CITY OF ALBUQUERQUE

Re: route 66 Plaza, 8521 Central Ave NE
Request for Certificate of Occupancy
Transportation Development Final Inspection
Engineer's/Architect's Stamp dated 05-17-16 (K19-D043)
Certification dated 06-14-18

DRAINAGE AND TRANSPORTATION INFORMATION SHEET (REV 11/2016)

ROUTE 66 PLAZA - LIVE/WORK DEVELOPMENT
SITE PLAN & PROJECT INFORMATION
8521 CENTRAL AVE. ALBUQUERQUE, NM
PROJECT #1611

SITE PLAN

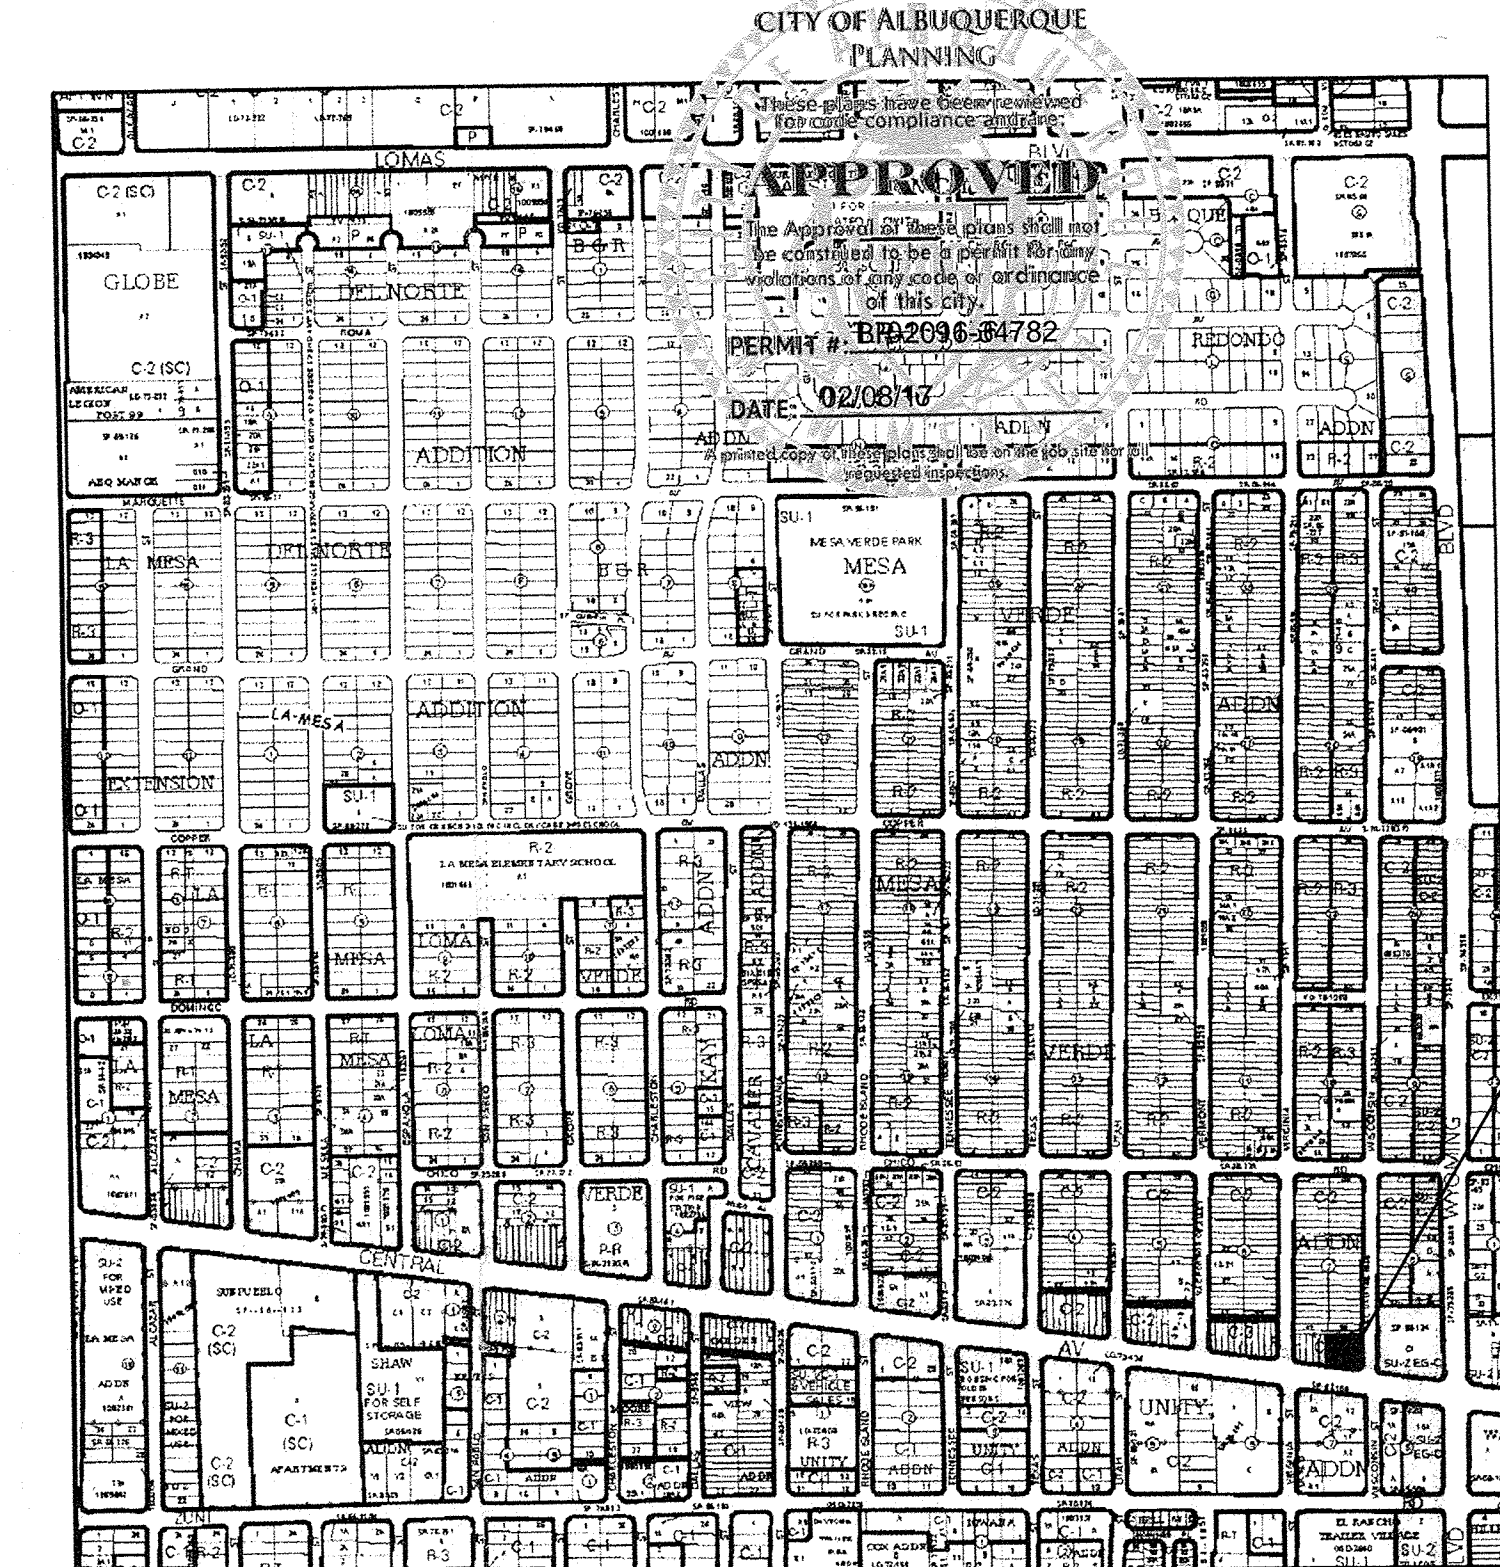
- The drive-up-window will not be allowed at this site. The drive through cannot be located adjacent to a fire lane, fire connect, or building egress/ingress. The site does not have enough room for car stacking.
- All unused curb cut and driveways must be closed with curb & gutter and sidewalk. City of Albuquerque standard drawing 2415A and 2430.
- The ADA accessible parking sign must have the required language per 66-7-352.4C NMSA 1978 **"Violators Are Subject to a Fine and/or Towing."**
- The ADA access aisles shall have the words **"NO PARKING"** in capital letters, each of which shall be at least one foot high and at least two inches wide, placed at the rear of the parking space so as to be close to where an adjacent vehicle's rear tire would be placed. (66-1-4.1.B NMSA 1978)

The changes to the approved T.C.L. by the owner/contractor have been Redline onto the original approved Traffic Circulation Layout document by **Rick Bennett Architect**. I further certify that I have personally visited the project site on June 14, 2018 and have determined by visual inspection that the Redline data provided is representative of actual site conditions and is true and correct to the best of my knowledge and belief. This certification is submitted in support of a request for Certificate of Occupancy (Permanent) for the Dentist Office located in Suite 101 at Route 66 Plaza, 8221 Central Ave. NE 87108, Lots 6, 7, 8, 9, 10, 11, Mesa Verde Addition, Bernalillo County, Albuquerque, New Mexico.

1. EXISTING ACCESSIBLE CONCRETE CURB RAMP TO REMAIN.
2. EXISTING RAISED CONCRETE CURB AND GUTTER TO REMAIN.
3. EXIST. CONC. SIDEWALK.
4. REMOVE EXIST. CONC. CURB AND GUTTER AND CONSTRUCT NEW RAISED CONCRETE CURB AND GUTTER PER C.O.A. STANDARD DRAWING 2484. ~~DELETED~~ **EXIST. TO REMAIN**

5. REMOVE EXIST. CONC. SIDEWALK AND CONSTRUCT NEW 7' WIDE CONC. SIDEWALK PER C.O.A. STANDARD DWG. 2299. ~~DELETED~~ **EXIST. 6'W TO REMAIN**
6. NEW 12' WIDE SIDEWALK CURB PER C.O.A. DWG. 2236. ~~DELETED~~ **DM!**

20. 2" WIDE PAINTED PARKING STRIP PER C.O.A. STANDARDS. REF: AS-2.0 FOR DETAILS.
21. CONCRETE WHEEL STOP. ~~DELETED~~ **DM!**
22. HANDICAP SYMBOL PER C.O.A. STANDARD. REF: AS-2.0 FOR DETAILS.
